DRAFT FINAL
SUPPLEMENTAL REMEDIAL INVESTIGATION REPORT
RADIOACTIVE WASTE BURIAL SITES (SEAD-12)

February 2006

**SUPPLEMENTAL REMEDIAL INVESTIGATION REPORT
RADIOACTIVE WASTE BURIAL SITES (SEAD-12)**

Response to Comments

FIGURE 3-2
SAMPLE LOCATIONS FROM
EXCAVATION AT
BUILDINGS 813 AND 814

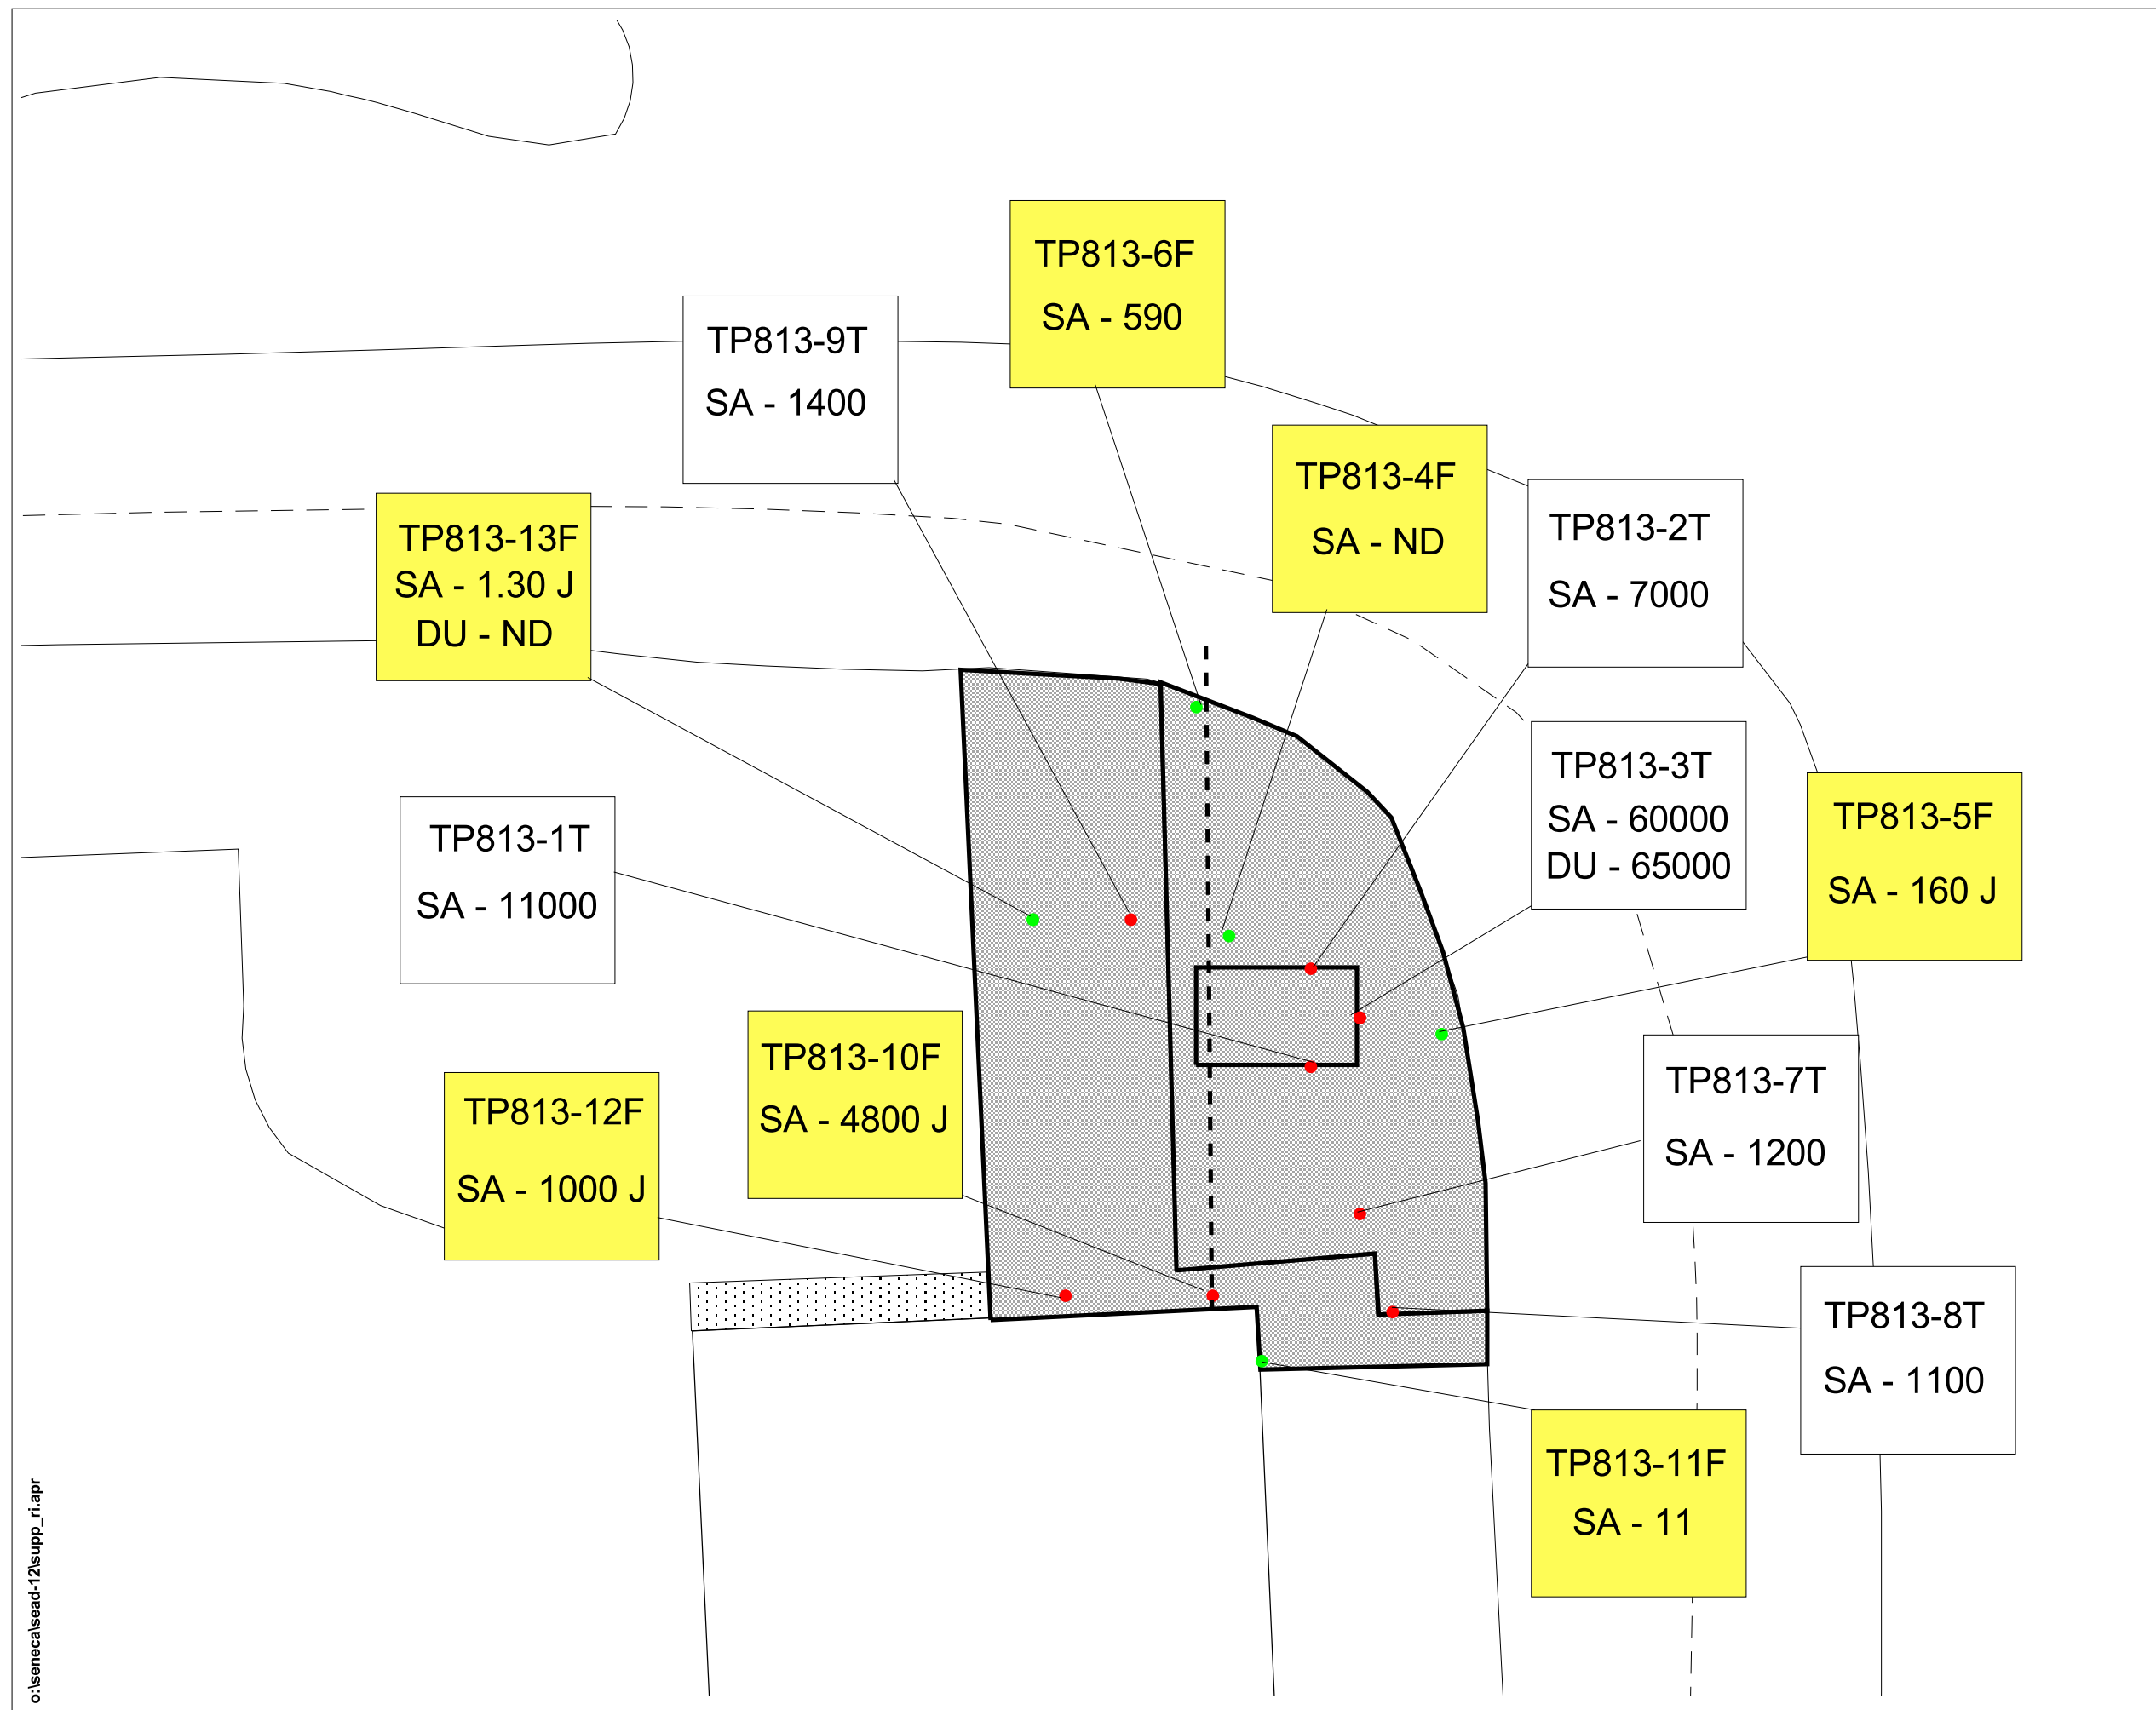
Comment 5: Appendix C: There was no identification on the Test Pit Reports to correspond to the Test Pits identified on Figure 3-2. Revise accordingly.

FIGURE 3-3
TCE CONCENTRATIONS IN
STOCKPILE SAMPLES AT
BUILDINGS 813 AND 814

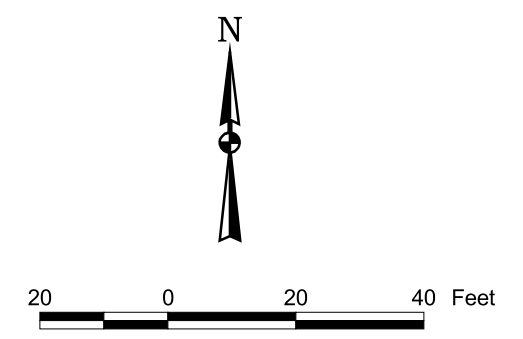
Comment 3: Page 4-3 Recommendations: The text states “The stockpiles remaining on-site will be re-sampled in the spring...”. Update the final version of the report with the results of that re-sampling.

Response 3: An update of the re-sampling of the stockpiles has been added to Section 3.3.2 and Section 4.2 and is summarized here.

Phase II and Phase III soils were re-sampled on July 22, 2005. Three additional grab samples were collected at random grid locations within the Phase II stockpile (see Figure 3-3). One additional sample was collected from this stockpile on November 28, 2005. Results indicated that TCE was detected below action levels for each sample and that this soil could be backfilled. Four additional grab samples were collected at random grid locations from the Phase IIIA stockpile. Results indicated that TCE was detected below action levels and that this soil could be backfilled. Two additional grab samples were collected from the Phase IIIB stockpile on a grid basis. One sample had concentrations that were below the TAGM for TCE. However, the other sample SP813-16 had TCE levels at 22,000 ug/Kg. Since this stockpile has not been sampled since July 2005, it will be re-sampled to see if levels have decreased since the summer months. This stockpile will be partitioned and sampled further to determine what portion of the soil may be returned to the excavation and what portion, if any, may need to be taken off-site for disposal. Four additional samples are being collected to make this determination.
